**SUNDRY NOTICES AND REPORTS ON WELLS**  
*Do not use this form for proposals to drill or to re-enter an abandoned well. Use form 3160-3 (APD) for such proposals.*

8. Well Name and No.  
BARLOW 34 FED COM 702H

EOG Resources requests an amendment to our approved APD for this well to reflect changes in casing design, TVD, and BHL as attached.

**Revised Permit Information 11/16/17:**

Lea County, New Mexico  
Proposed Wellbore  
Revised 11/16/17  
API: 30-025-44181

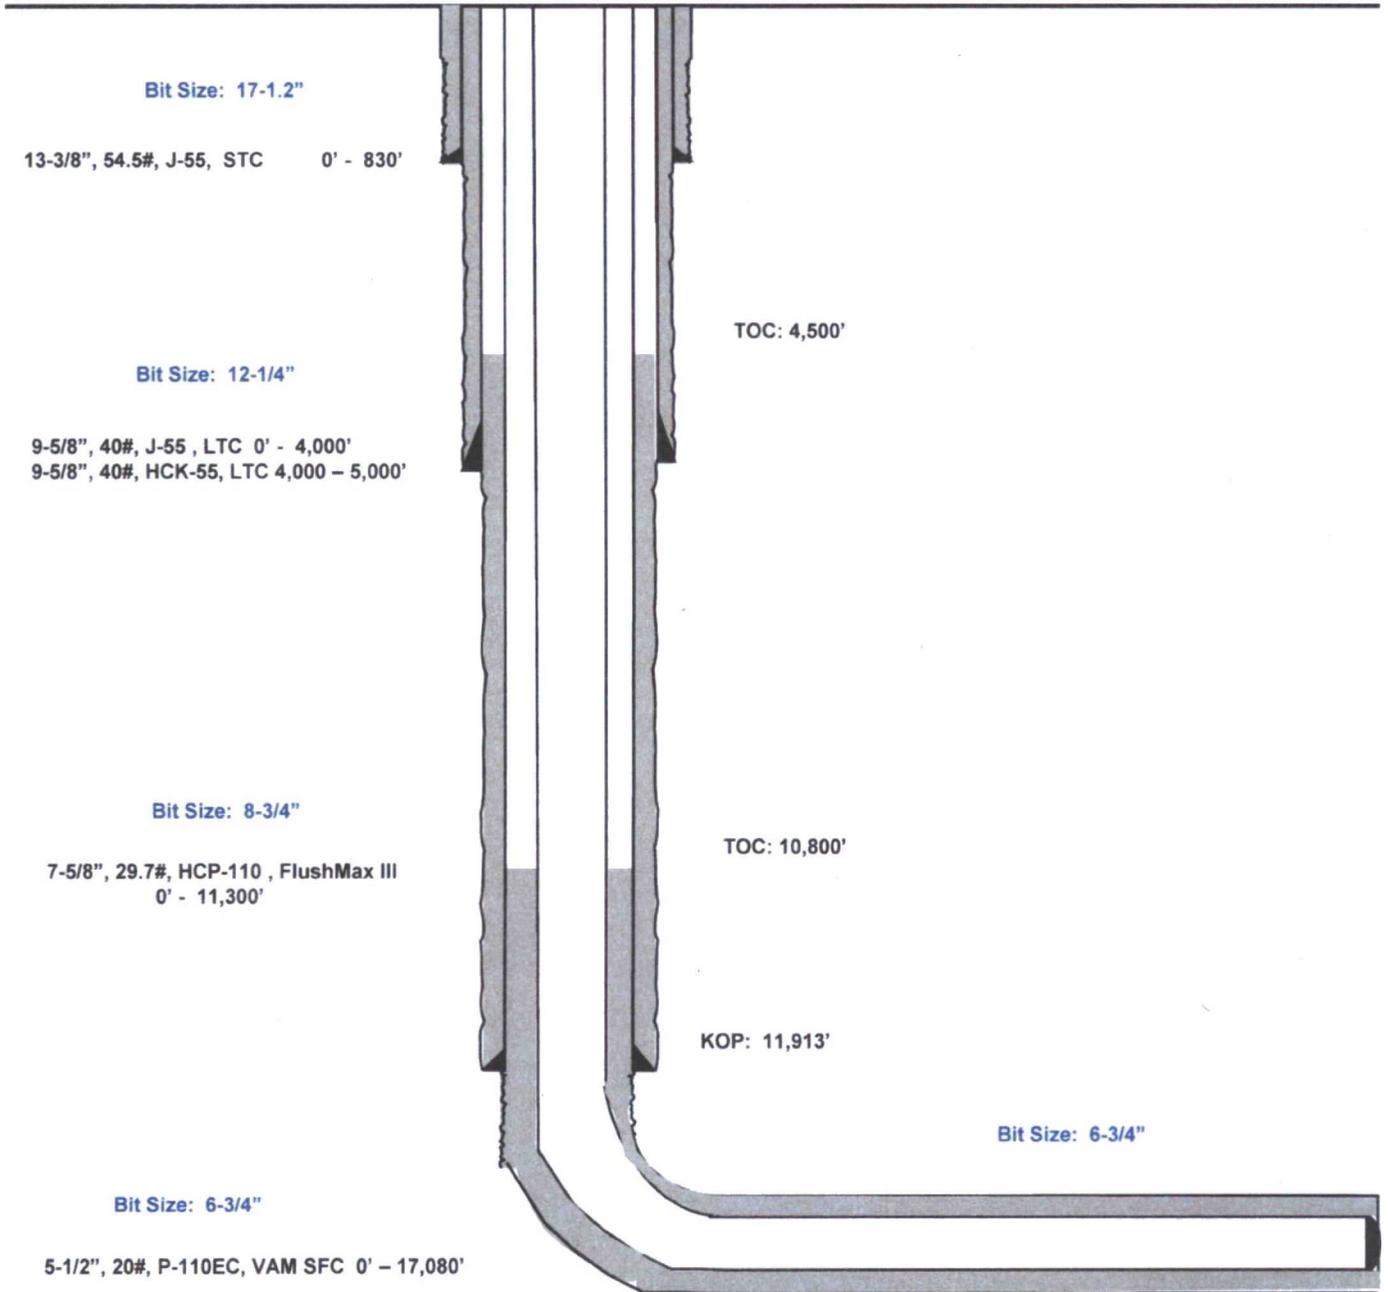
Change to 4-string casing design

Change BHL to 2427' FSL & 830' FWL, 27-26S-33E  
Change TVD to 12400' Upper Wolfcamp

Hole Size	Interval	Csg OD	Weight	Grade	Conn	DF <sub>min</sub> Collapse	DF <sub>min</sub> Burst	DF <sub>min</sub> Tension
17.5"	0 - <del>830'</del> 875'	13.375"	54.5#	J55	STC	1.125	1.25	1.60
12.25"	0-4,000'	9.625"	40#	J55	LTC	1.125	1.25	1.60
12.25"	4,000' - 5,000'	9.625"	40#	HCK55	LTC	1.125	1.25	1.60
8.75"	0 - 11,300'	7.625"	29.7#	HCP-110	FlushMax III	1.125	1.25	1.60
6.75"	0'-17,080'	5.5"	20#	HCP-110	VAM SFC	1.125	1.25	1.60

1. The 13 3/8 inch surface casing shall be set at approximately 875 feet (**in a competent bed below the Magenta Dolomite, which is a Member of the Rustler, and if salt is encountered, set casing at least 25 feet above the salt**) and cemented to the surface.

2. The minimum required fill of cement behind the 9-5/8 inch intermediate casing, which shall be set at approximately 11300 feet (**basal anhydrite of the Castile formation or the top of the Lamar Limestone**), is:
  - Cement to surface. If cement does not circulate see B.1.a, c-d above.
3. The minimum required fill of cement behind the 5-1/2 inch production casing is:
